# Access Compliance Report

## Public Rights-of-Way

| Intersection ID: 10018981               | Main Street: DEVONGATE_LN | Cross Street: DEVONGATE_LN              | Location: NW           |
| ADA ID: 3C904330034B                    | Ramp Type: PerpDiag       | Initial Pass/Fail: Fail                 | Overall Compliance: No |

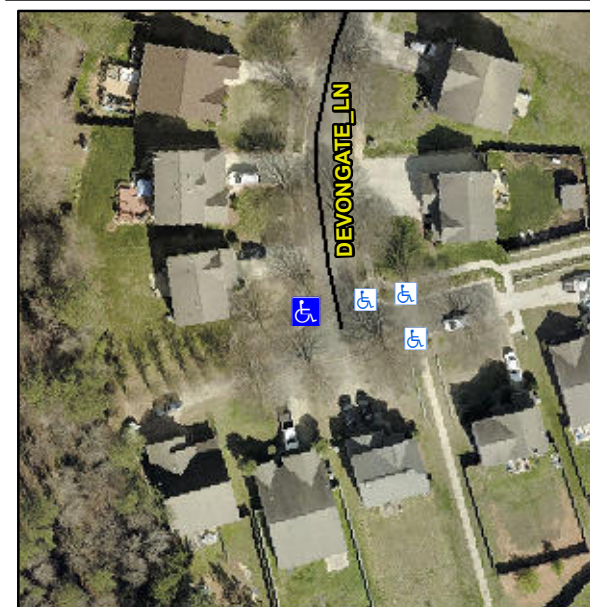
**Not Found, R304.5.1, R304.5.3**

| Compliance | Description           | Data | Compliance | Description                 | Data |
|------------|-----------------------|------|------------|-----------------------------|------|
| N/A        | Ramp Length (in)      | 58.0 | Yes        | Ramp Slope (%)              | 6.4  |
| No         | Ramp Width (in)       | 34.5 | No         | Ramp XSlope (%)             | 3.6  |

**Remove & Replace Curb Ramp With Two New Directional Ramps or Equivalent.**
